**0012** Technical Service Information**Subject:** Cylinder head gaskets**Relates to:** 61-33495-00 / -10**Make:** Opel**Model(s):** Agila, Corsa**Engine code:** X 10 XE, Z 10 XE**Repair thickness CHG 1.0 Opel  
Ecotec X 10 XE / Z 10 XE**

Figure\_Cylinder head gasket, Reinz no. 61-33495

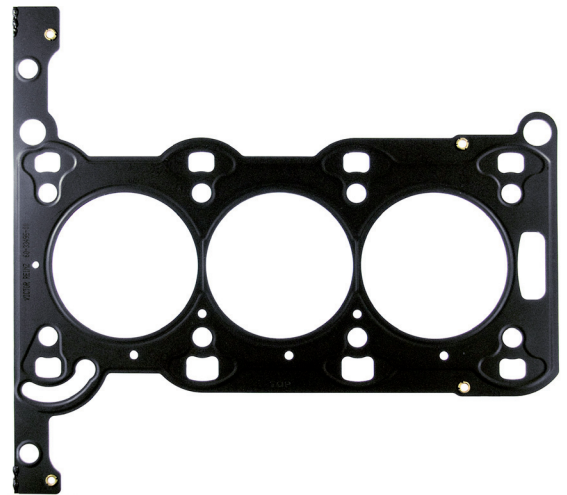
With the new exclusive repair thickness for the Cylinder Head Gasket 61-33495-00 = Opel 56 07 058, Dana offers the perfect solution for reliable sealing of reworked cylinder heads and cylinder blocks.

The repair thickness is 0.25 mm thicker than the original. After necessary surface machining, this thickness thus offers best sealing results up to this measurement.

The order number for the repair thickness is **61-33495-10**.

Caution: After the cylinder head and cylinder block have been machined, the surface roughnesses must be in a tolerance band between 7 µm and 20 µm. The waviness value should not exceed 20 µm.
